Technical Service Bulletin

Subject: 05-002/17 HARD SHIFTING/SHIFT LEVER VIBRATION	Bulletin No.: 05-002/15
	Last Issued: 06/12/2017

BULLETIN NOTES

Location of Transmission Related Parts

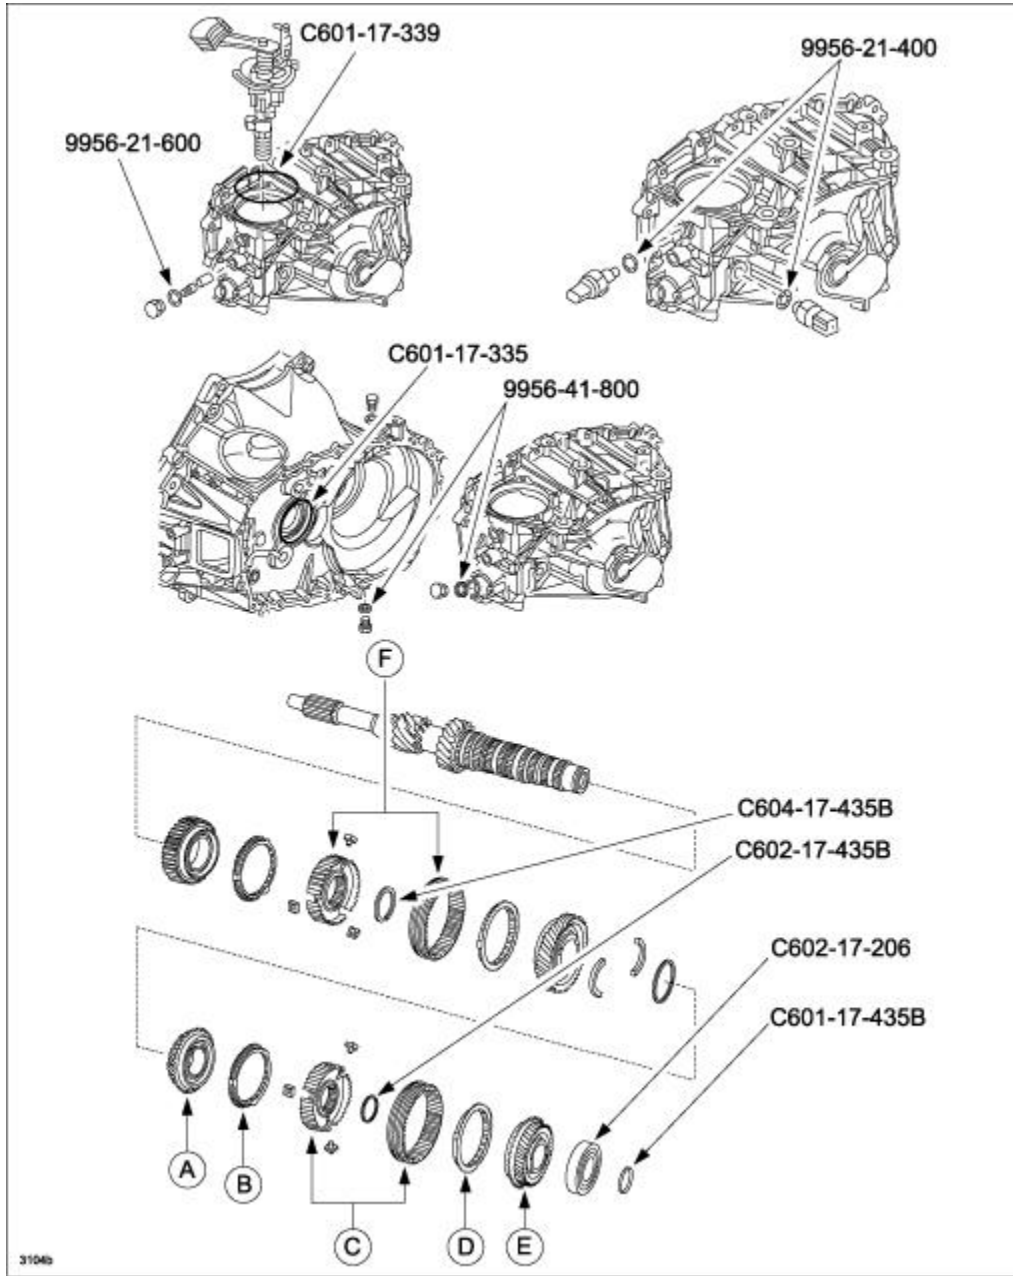
NOTE: Refer to the following illustrations for the parts location. Confirm the part numbers in the GEPC for the subject VIN and place an order for the corresponding (modified) service part.

Parts Number	Description	Qty.	Notes
C602-17-240B	3-4 Clutch Hub Assembly	1	
C602-17-620C	5-6 Clutch Hub Assembly	1	
C601-17-230D	3rd Gear	1	Part numbers of gears are different depending on the variation of the gear ratio. Check EPC for the correct part number for the repair VIN.
C610-17-230C			
C602-17-26YB	Synchronizer Ring	2	
C601-17-210E	Gear, Main Drive (See note below)	1	
C603-17-210B	Reamer Bolt	6	Replacement parts that are necessary for all repairs.
C613-17-210B	Retaining Ring	1	
C604-17-435B	Retaining Ring	1	
D602-17-435B	Retaining Ring	1	
C602-17-206	Ball Bearing	1	
C601-17-339	"O" Ring	1	
C601-17-335	Oil Seal	1	
9956-21-400	Washer	2	
9956-21-600	Washer	1	
9956-41-800	Washer	2	
0000-77-5W80-QT	Manual Transaxle Oil	3	Specification: 2.6 - 2.7 US qt
